SENDLEWSKI ARCHITECTS, PC
ARCHITECTS – PLANNERS

ADDENDUM NO. 1
ISSUED 08-15-22

FIREHOUSE FACILITY PROJECTS
TAPPAN FIRE DISTRICT
PROJECT No. 2108.01A, 2108.01B, 2108.02

CONCRETE APRON

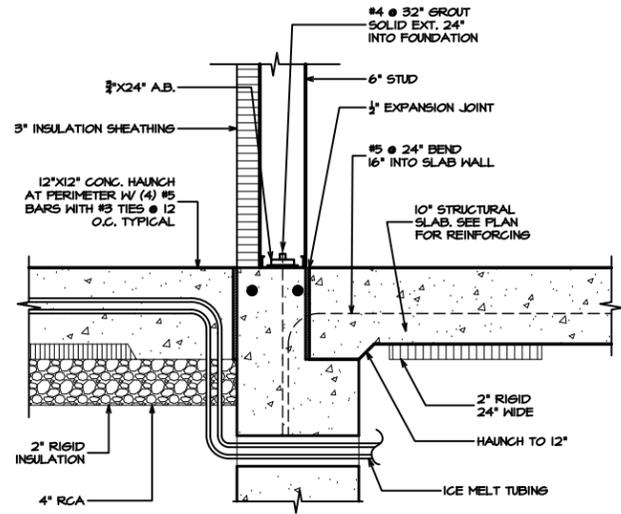
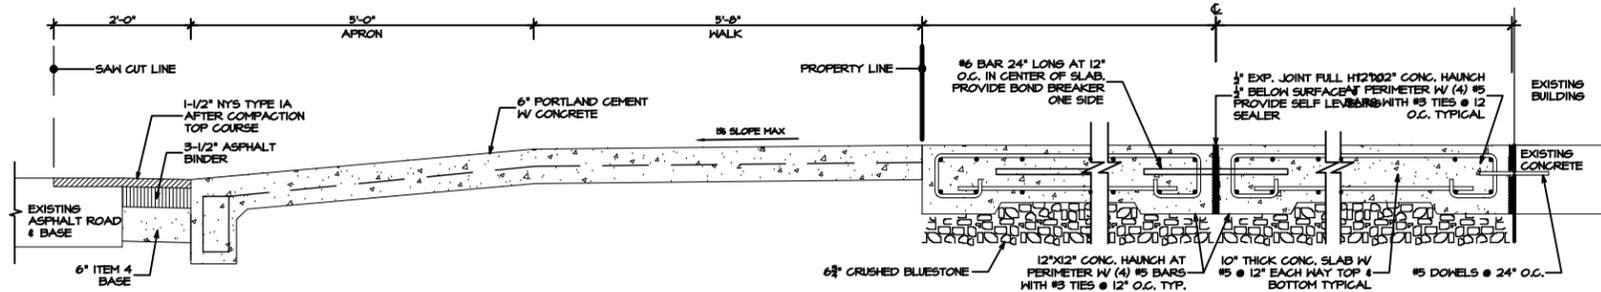
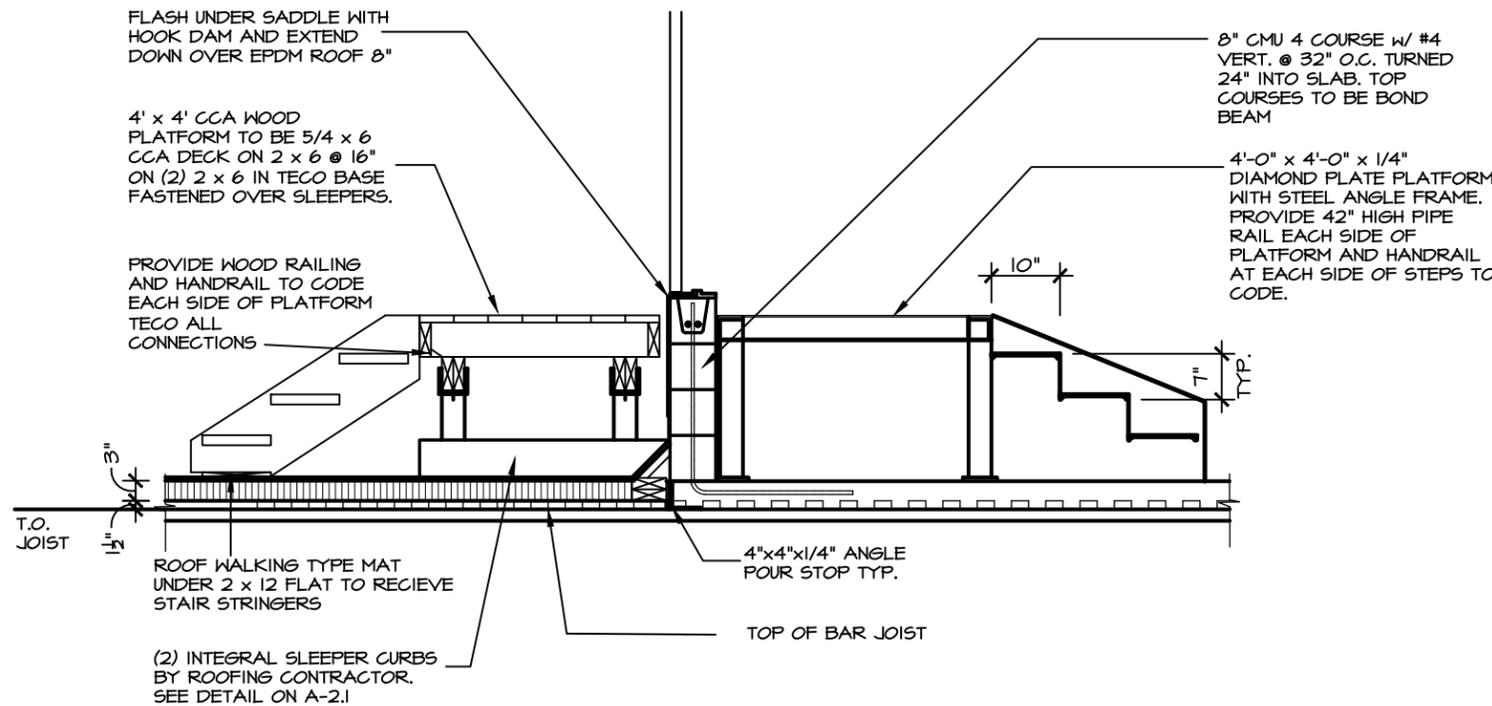
7. Omit recessed floor mats at vestibules.
8. Apron slab and joints and details to be per **Attachment "B"-1**.
9. Add alternate for apron insulation for ice melt system shall be per **Attachment "B"-2**.

VB0240

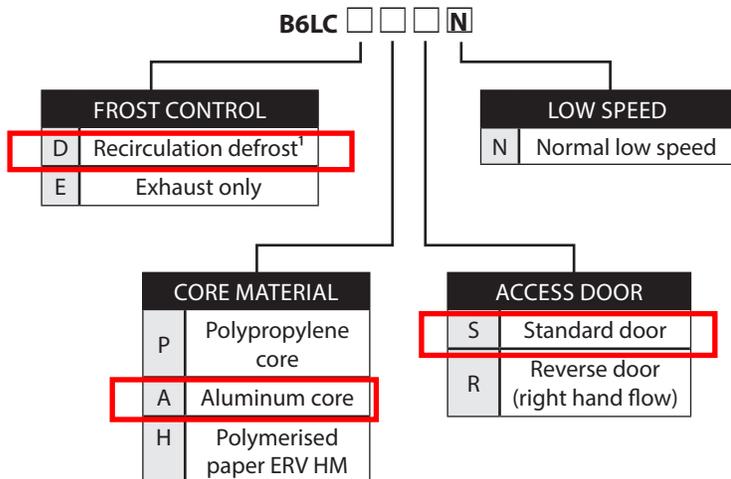
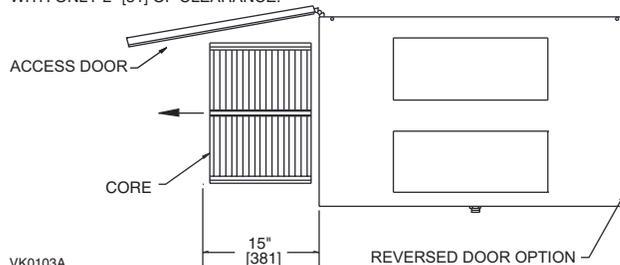
7. Omit BAS system in its entirety. Controls to be as local control at each room.
8. Omit air purifier AP-1 in gear area.
9. Provide HRV ventilation system at gear area in bays, see **Attachment "D"**.

8. Provide HRV ventilation system at gear area in bays per Attachment "D".
9. CO venting detector to be tied into overhead door and fan controllers to open doors when activated. Coordinate with electric and general contractors.

A-3.1

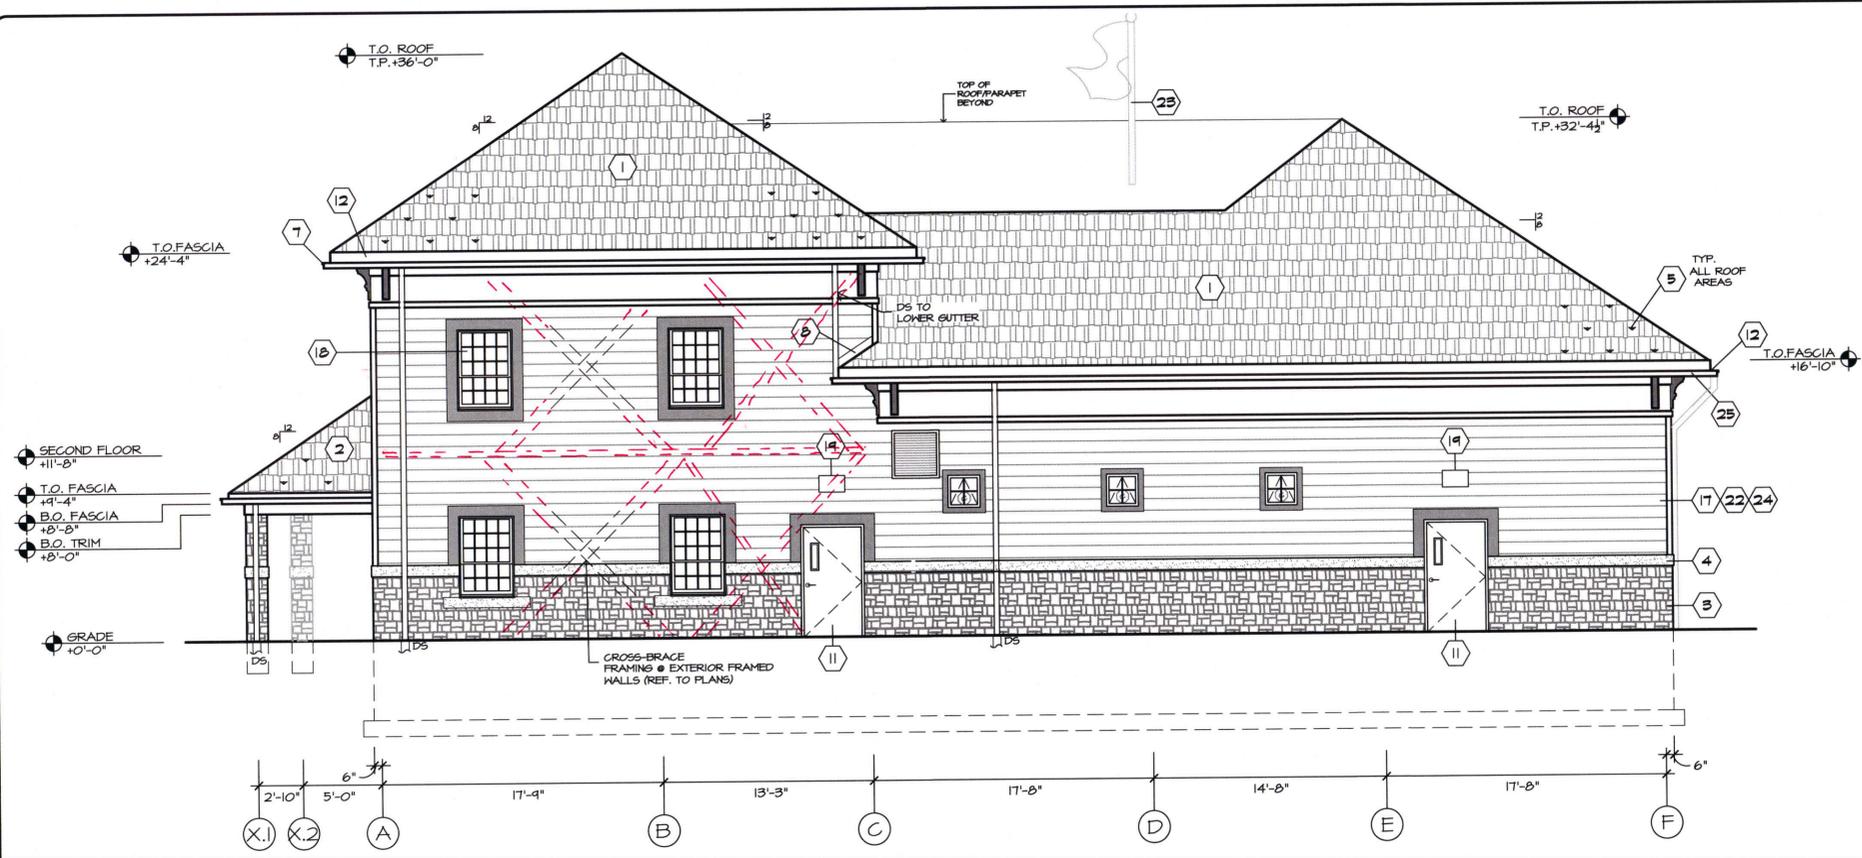
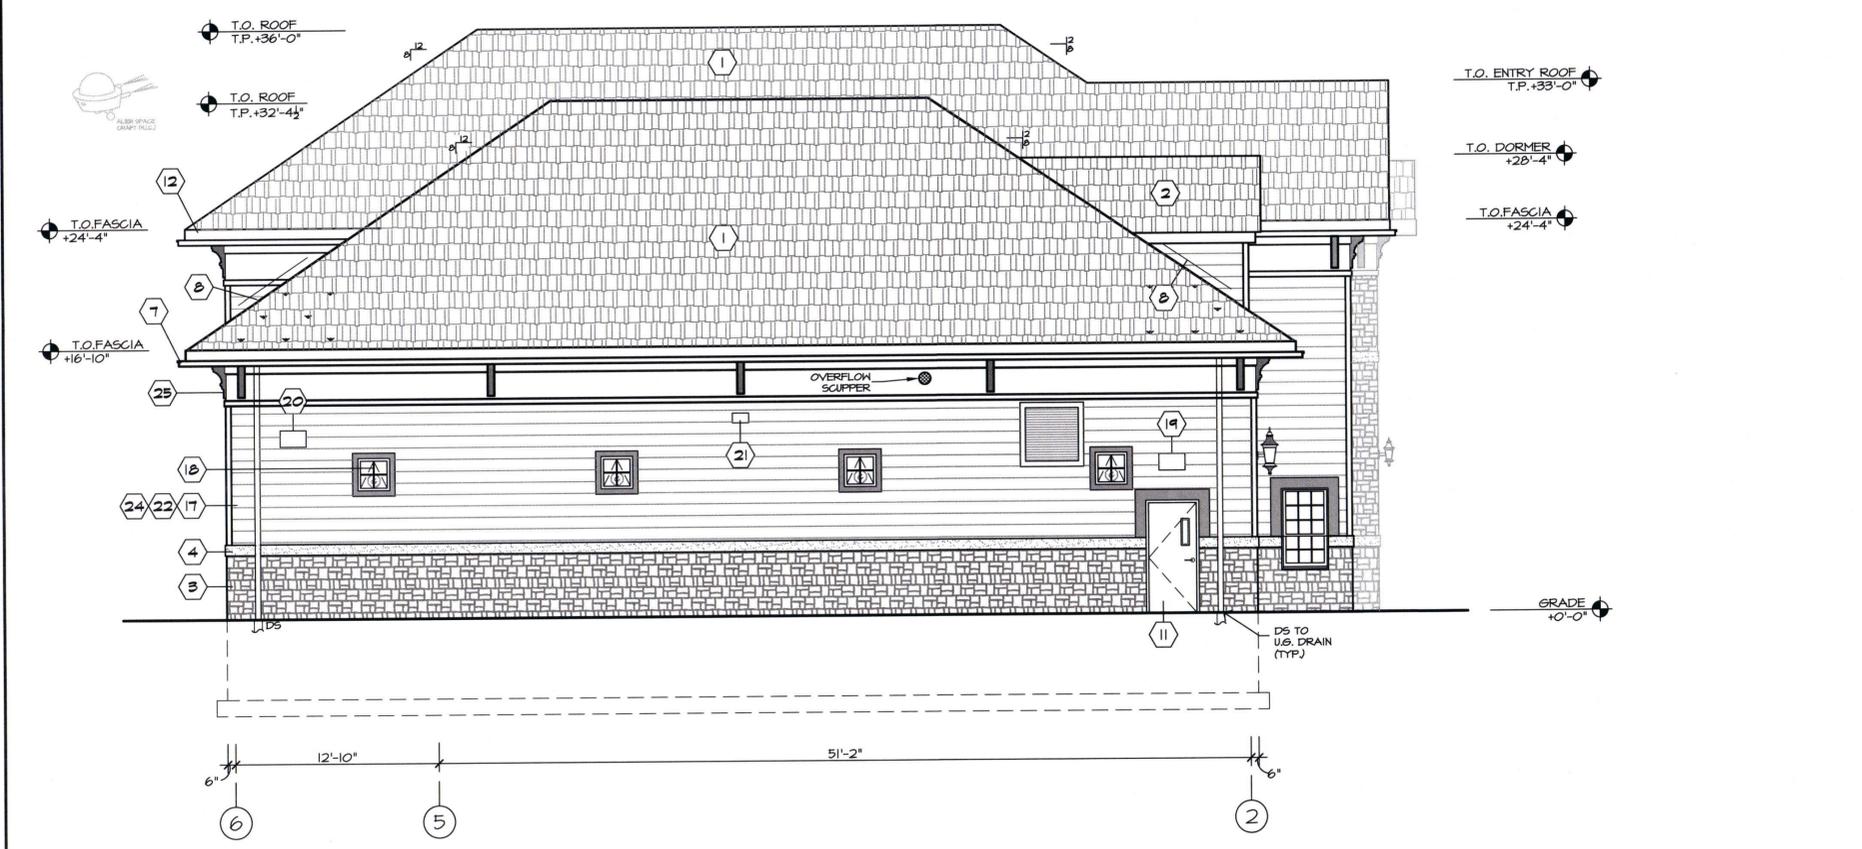
2. North & south elevation designations are reversed on drawing A-3.1.
3. Trenching and 95% compaction backfill for all trade utilities to be by respective trade contractor.

A-6.1

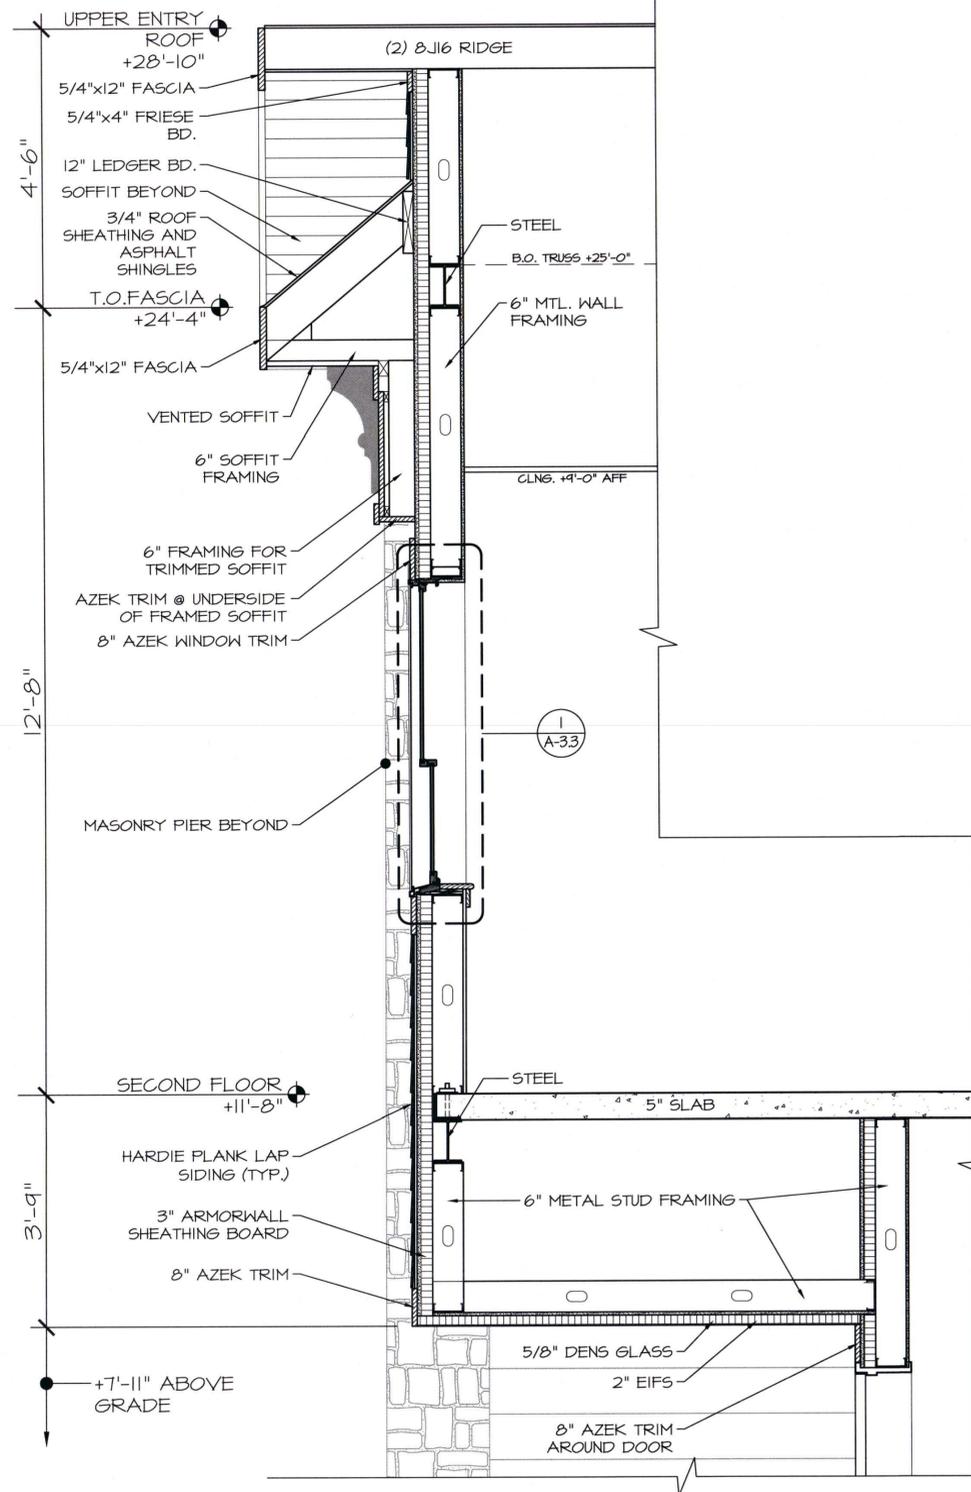
- **A-6.2** – Changes made to Wall Section 'B'.
 - **S-1.1** – Changes made to Foundation Plan, Pile Cap Details, and Grade Beam Schedule.
 - **S-1.2** – Changes made to Detail 'E'.
